The Commission has issued the enclosed Amendment No. 12 to Facility License No. DPR-20, for the Palisades Plant. This amendment includes Change No. 16 to the Technical Specifications, and is in response to your request dated April 8, 1974.

AMENDMENT TO PROVISIONAL OPERATING LICENSE

Amendment No. 12
License No. DPR-20

ATTACHMENT TO LICENSE AMENDMENT NO. 12
CHANGE NO. 16 TO THE TECHNICAL SPECIFICATIONS
PROVISIONAL OPERATING LICENSE NO. DPR-20
CONSUMERS POWER COMPANY
PALISADES PLANT
DOCKET NO. 50-255

FIGURE 4.12 A

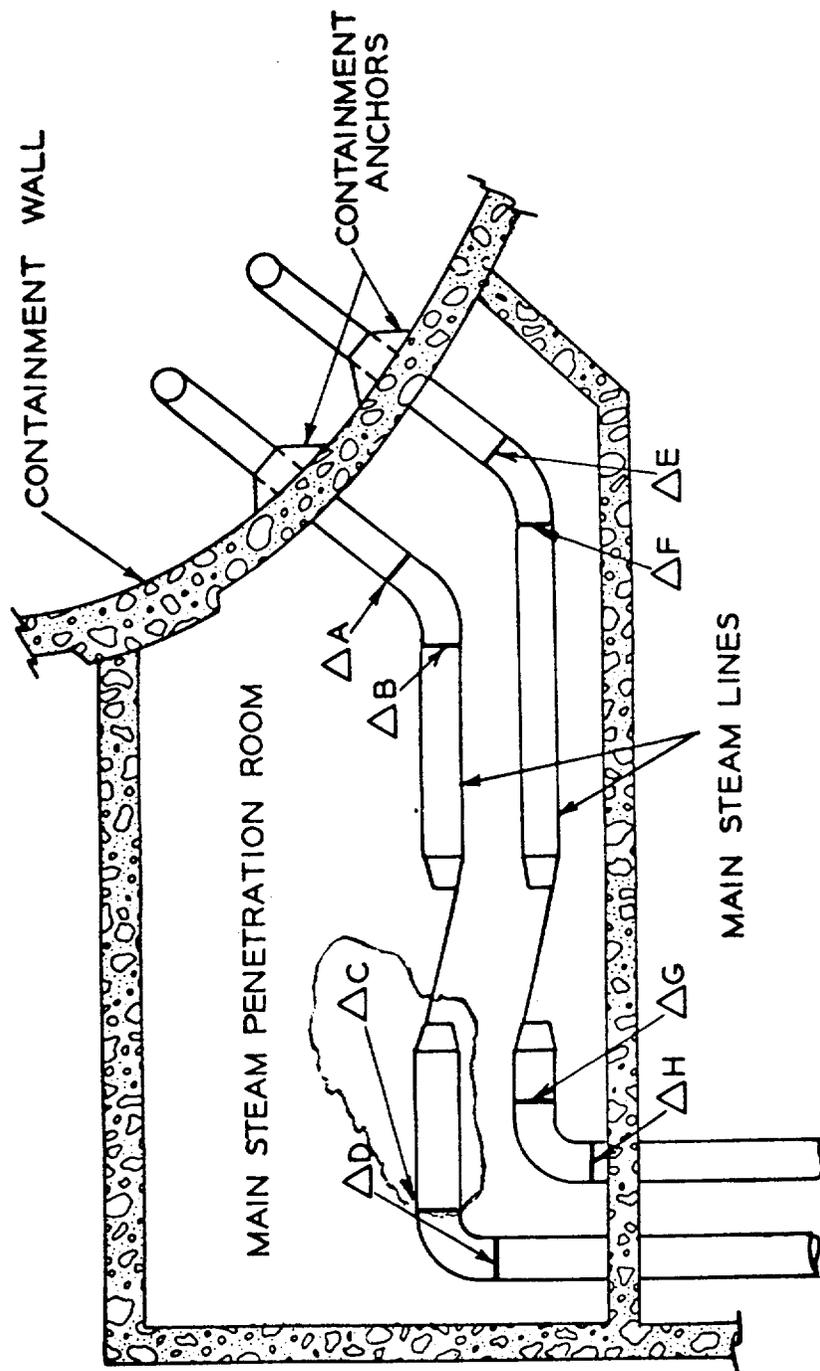
4-63	Figure 4.12A	Corrects drafting error in figure.
